Final Report - Corrections Required **Application No. ANEX-24-0004**

Description : Matrix Design Group on behalf of Colorado Springs Equities LLC is submitting a serial annexation petition for seven parcels and Land Use Plan/Rezoning exhibit for a portion of the subdivision known as Rock Creek Mesa.

ANNEXATION PLAT ROCK CREEK MESA ADDITION NO. 4

ROCK CREEK MESA ADDITION NO. 4

ANNEXATION PLAT

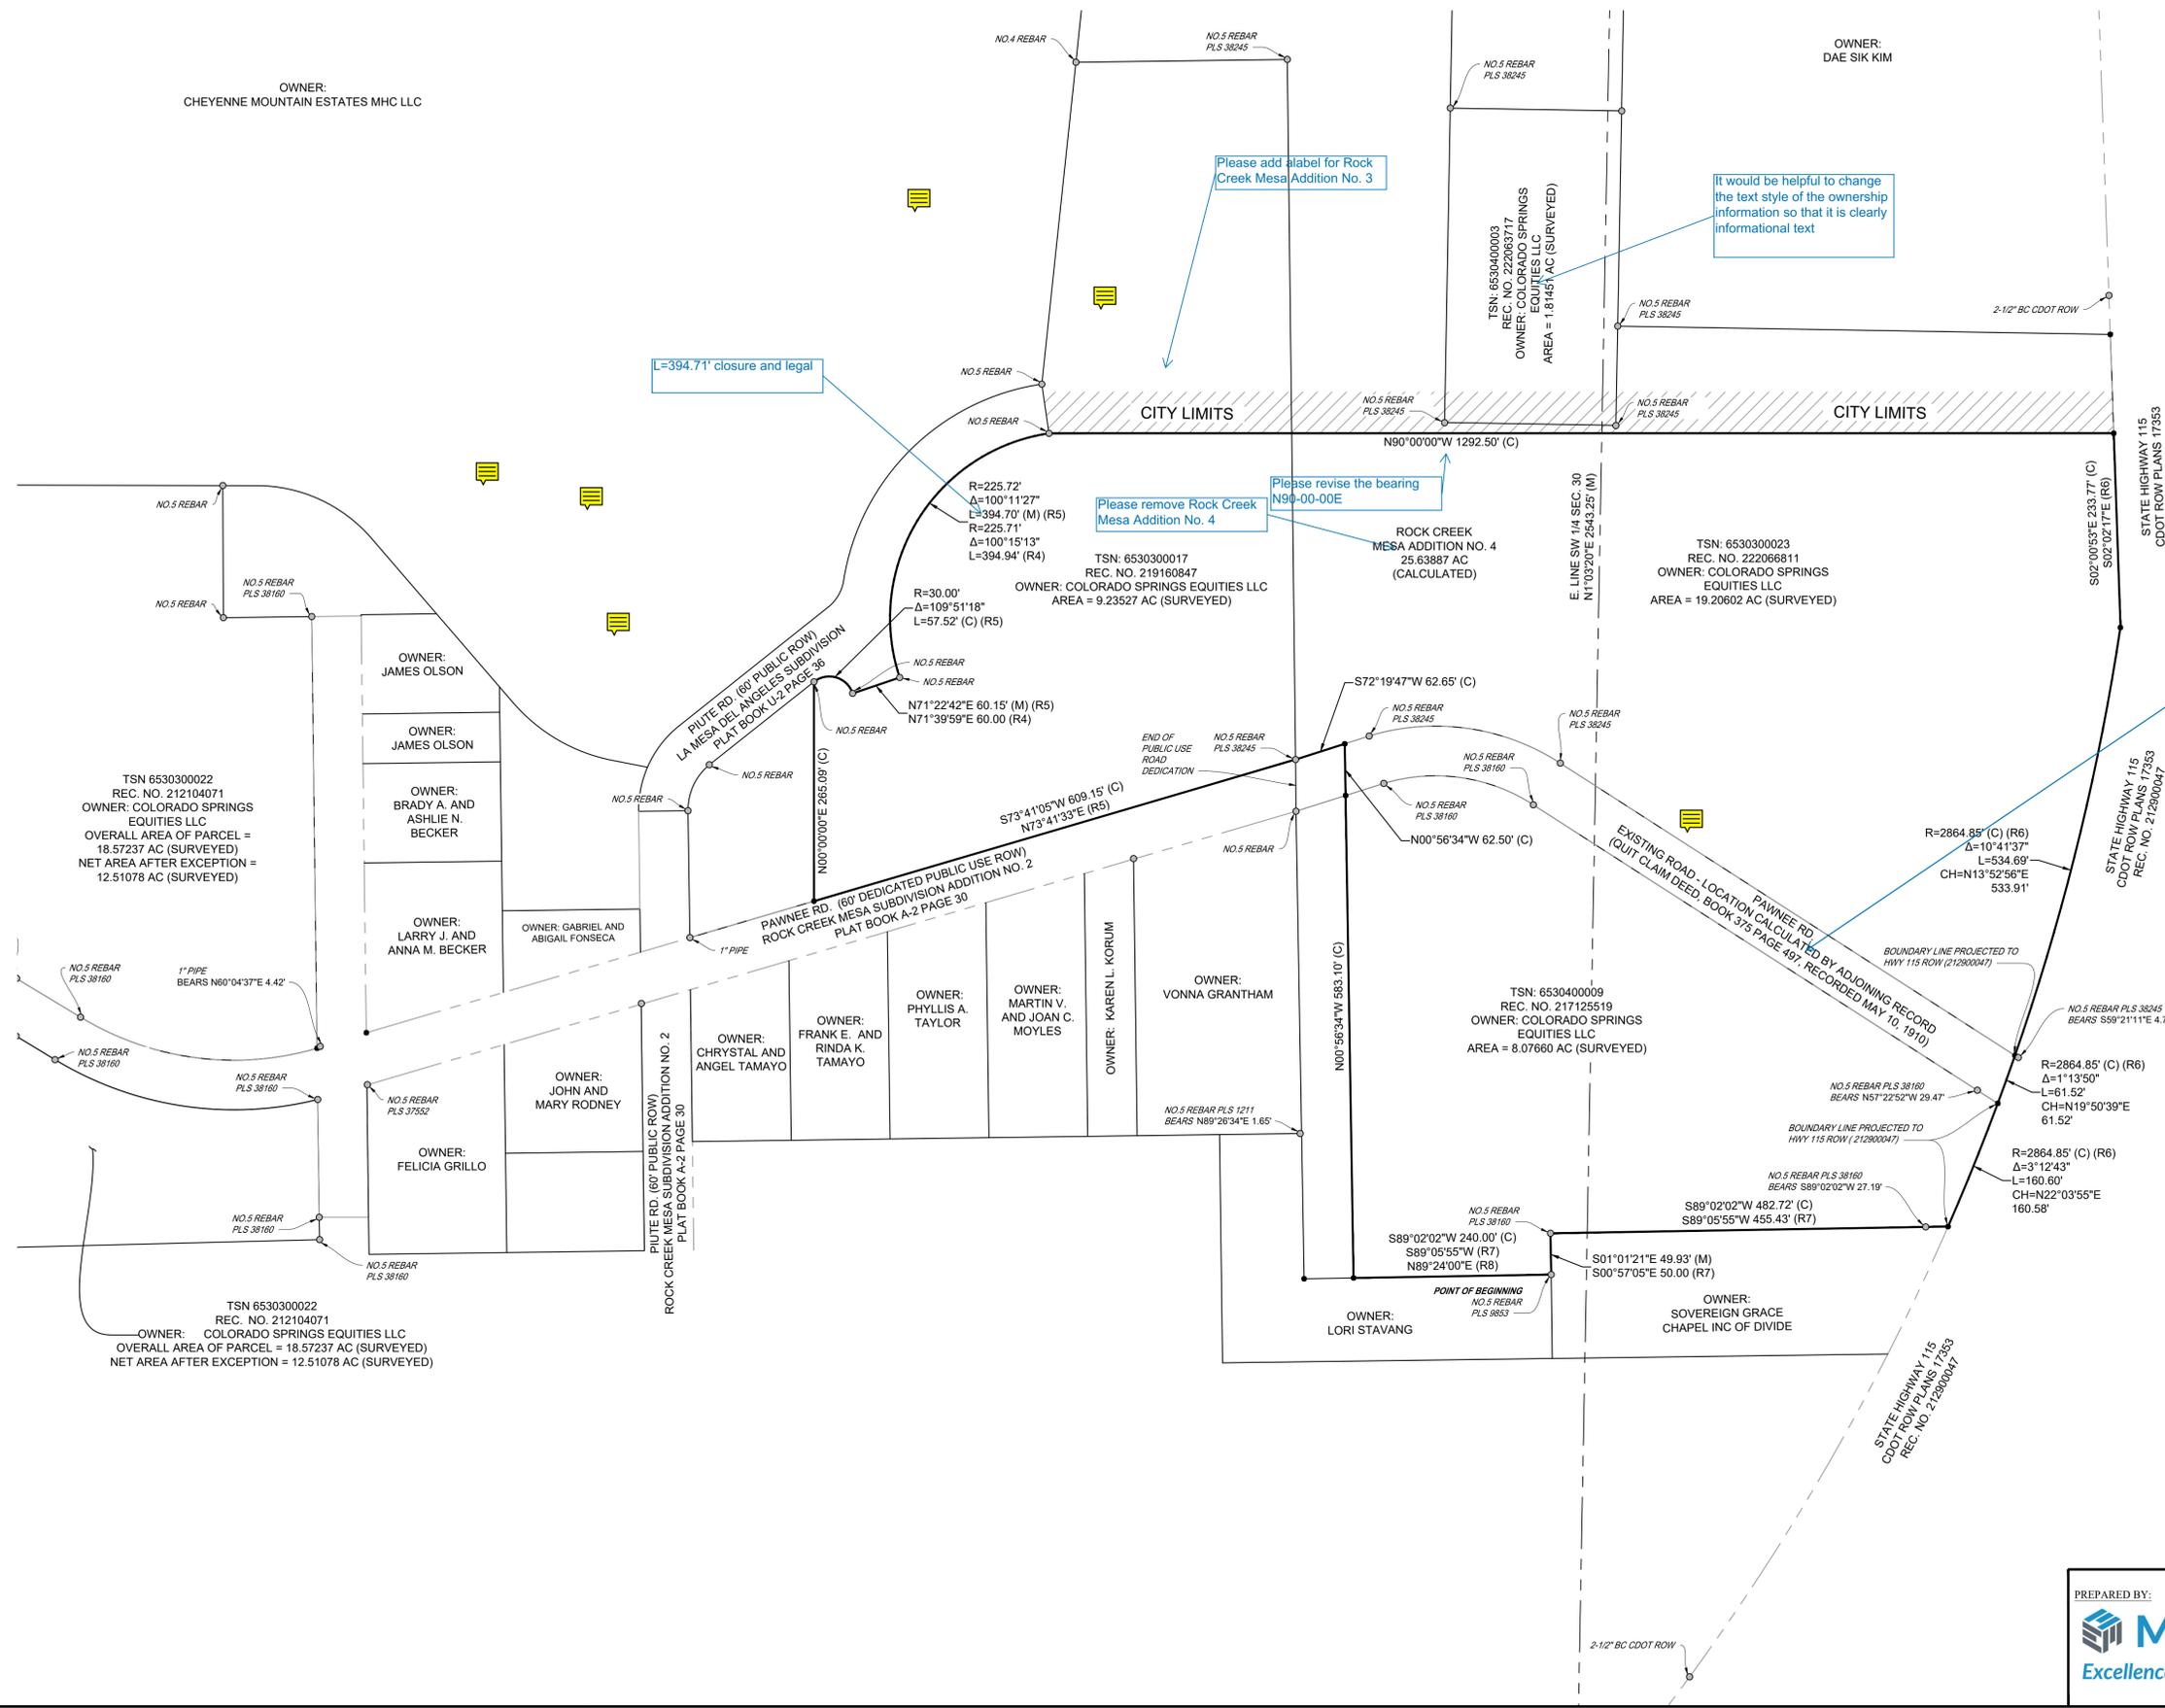
L=394.71' closure and legal

Please add label for Rock Creek Mesa Addition No. 3

It would be helpful to change the text style of the ownership information so that it is clearly informational text

Please remove Rock Creek Mesa Addition No. 4

Please revise the bearing N90°00'00"E

Please add (M) and (C) to the legend

Question for Surveyor, does this resolve the road
